Project No. 11013.80

**GEORGETOWN MIDDLE-HIGH SCHOOL RENOVATIONS
Georgetown, MA**

ADDENDUM NO.4

February 23, 2015

RM4-01
 Ref. Dwg. M1-1-2A

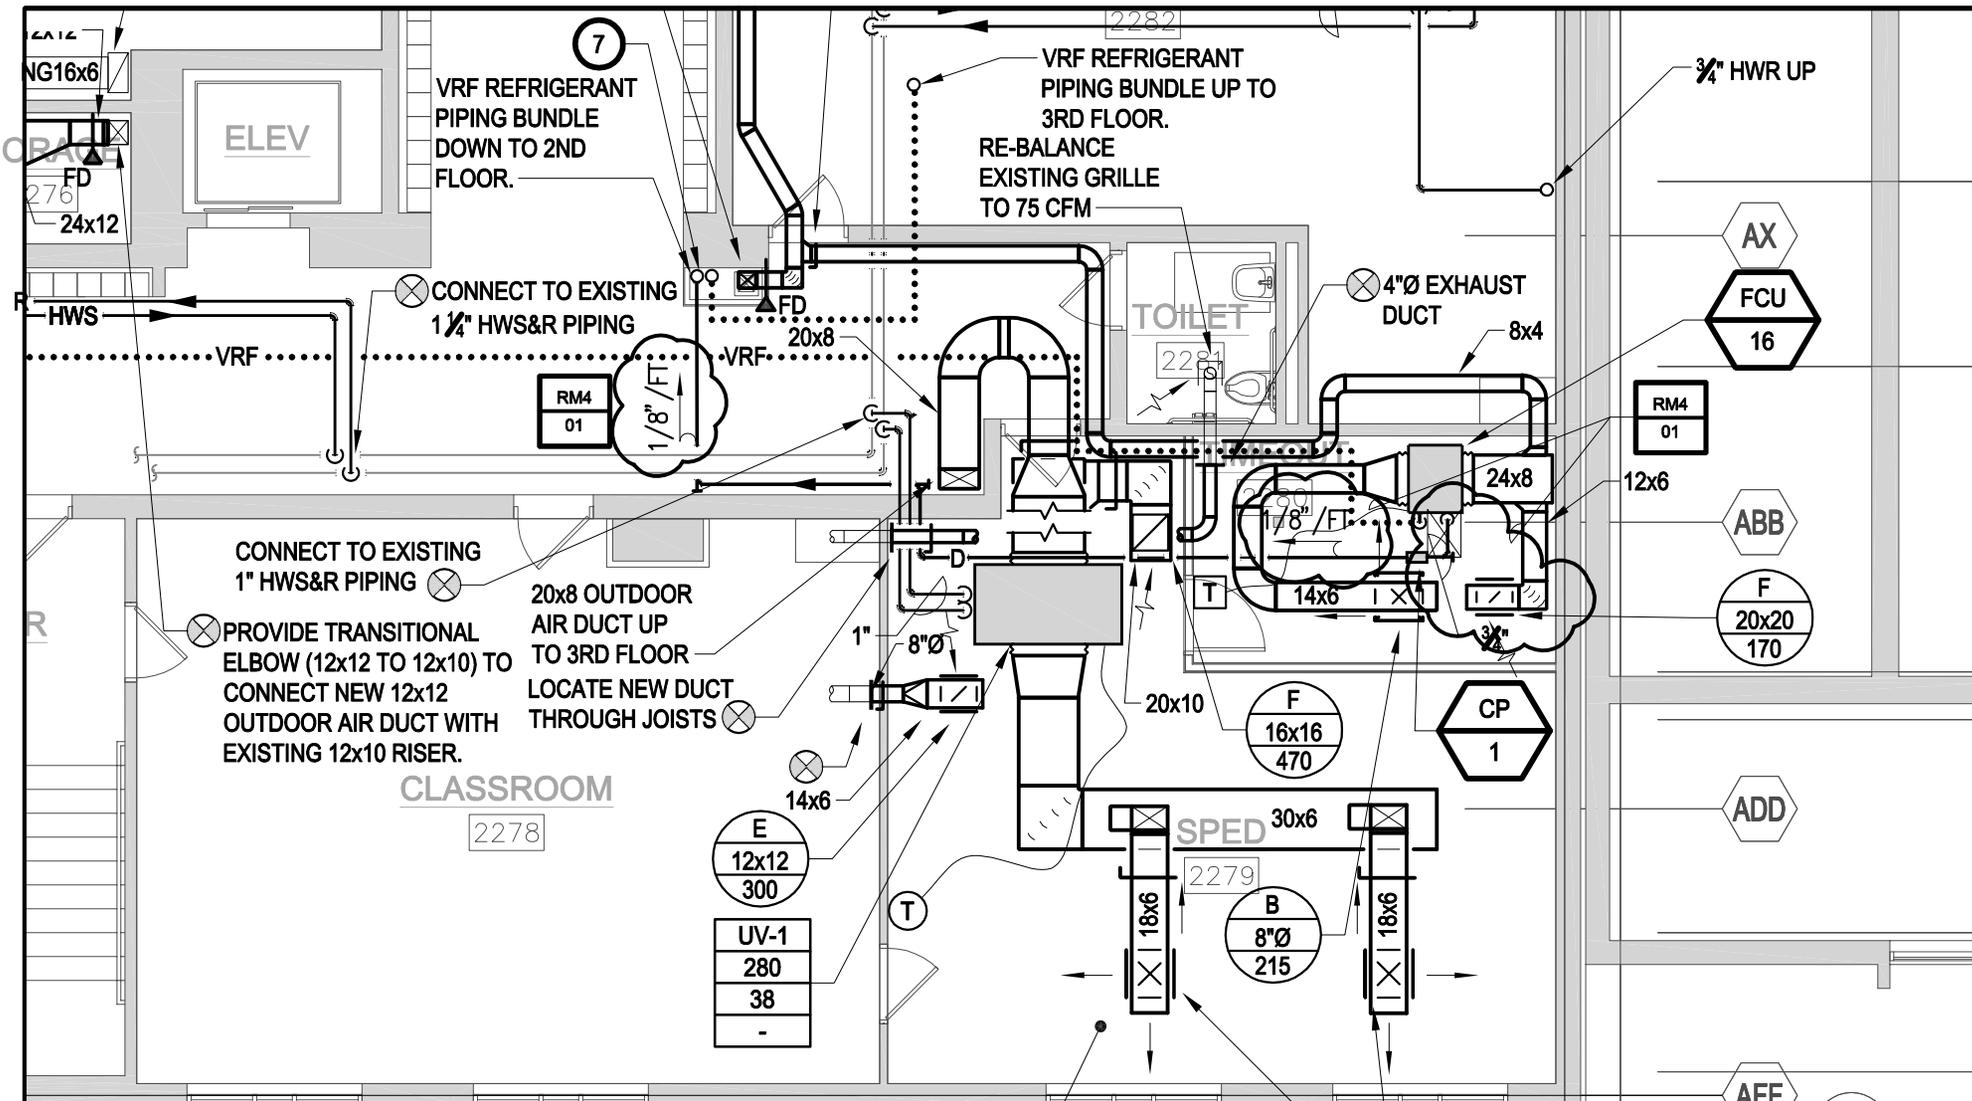
MECHANICAL
ADD 4-03 ADD SKETCH RM4-01
